Title - Sujet First Stage In Situ Remediation	
Solicitation No. - N° de l'invitation EZ897-180850/A	Amendment No. - N° modif. 001
Client Reference No. - N° de référence du client	Date 2017-08-14
GETS Reference No. - N° de référence de SEAG PW-\$PWY-004-8128	
File No. - N° de dossier PWY-7-40138 (004)	CCC No./N° CCC - FMS No./N° VME
Solicitation Closes - L'invitation prend fin at - à 02:00 PM on - le 2017-08-23	Time Zone Fuseau horaire Pacific Daylight Saving Time PDT
F.O.B. - F.A.B. Plant-Usine: <input type="checkbox"/> Destination: <input checked="" type="checkbox"/> Other-Autre: <input type="checkbox"/>	
Address Enquiries to: - Adresser toutes questions à: Mestry, Ruth (PWY)	Buyer Id - Id de l'acheteur pwy004
Telephone No. - N° de téléphone (778) 995-4613 ()	FAX No. - N° de FAX (604) 775-6633
Destination - of Goods, Services, and Construction: Destination - des biens, services et construction: PWGSC - Muncho Lake & Fireside Maintenance Camps, km 698 & km 839 - Alaska Highway, BC

Maintenance Camp Insitu Muncho Lake and Fireside Camp, Alaska Highway, B.C.

Addendum No. 1

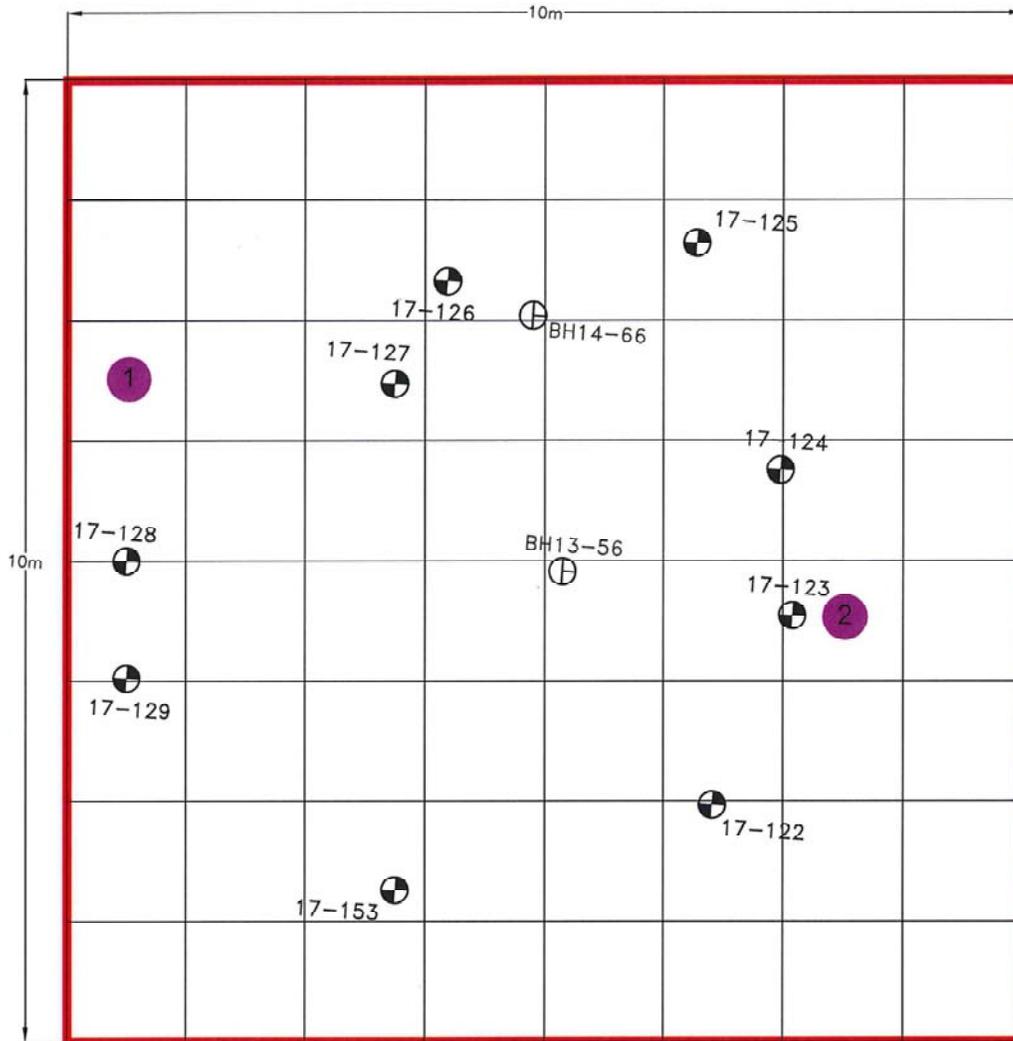
- Drawing 635031-805 – Notes 3 and 4 have been modified to indicate a solution of hydrogen peroxide, potassium citrate, and citric acid.
- Drawing 635031-806 – Drawing Title has been modified to indicate work as Optional Work.
- Drawing 635031-807 - Note 4 has been modified to indicate a solution of hydrogen peroxide, potassium citrate, and citric acid.
- Drawing 635031-810 - Note 4 has been modified to indicate a solution of hydrogen peroxide, potassium citrate, and citric acid.
